Millennium Mine

It is advised that MetRes Pty Ltd has lodged an application for a major amendment to an environmental authority in accordance with the requirements of the *Environmental Protection Act 1994*. The environmental authority being amended is EPML00819213.

The submission package under assessment is the proponents response to an information request (IR) received by the administering authority on 15 August 2024.

**Millennium Coal Mine EPML00819213
Environmental Authority amendment
Information Request Response**

Figure 12 MB9B – Aluminium data and trend analysis

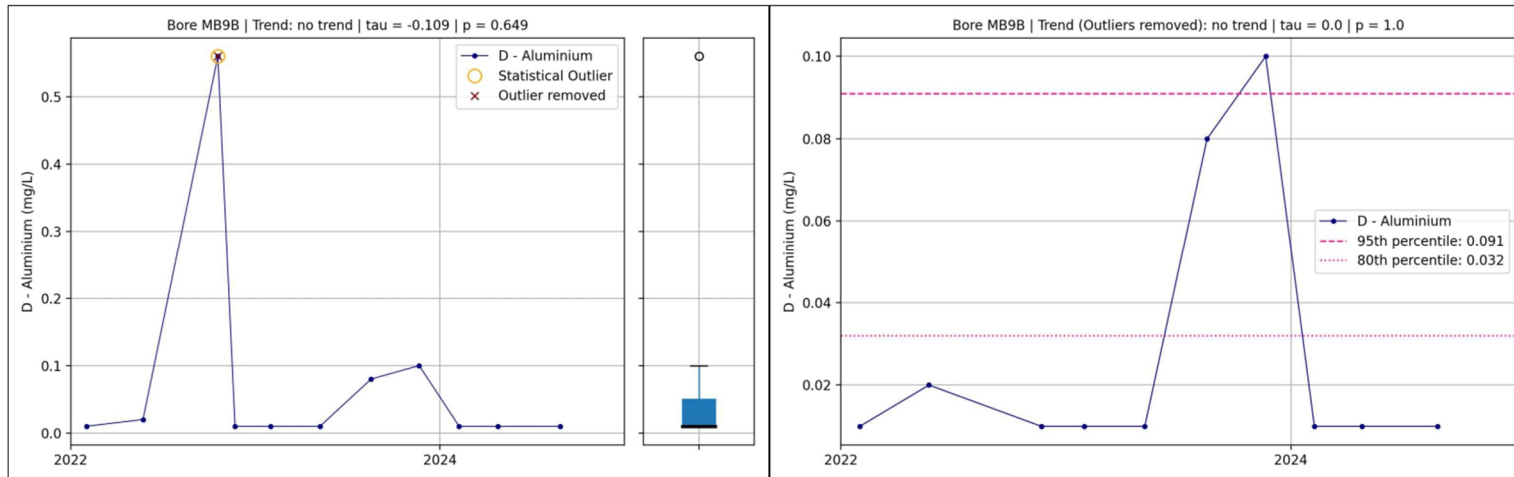
- If the three (3) exceedances condition is to be adopted for all bores and all parameters, provide more groundwater monitoring data for the bores which do not currently have sufficient data points to allow derivation of bore specific values.
- Confirm if agree to maintain default guideline values and relevant trigger exceedance limit as per current Condition D4.0 for bores which do not have sufficient data to derive bore specific limits
- Explain the increasing Aluminium trends in bores MB9A and MB9B

- c) The apparent observed increasing Aluminium trends in bores MB9A and MB9B, noted as two points trending upwards in late 2023, has since ceased, with stable parameters observed in 2024.
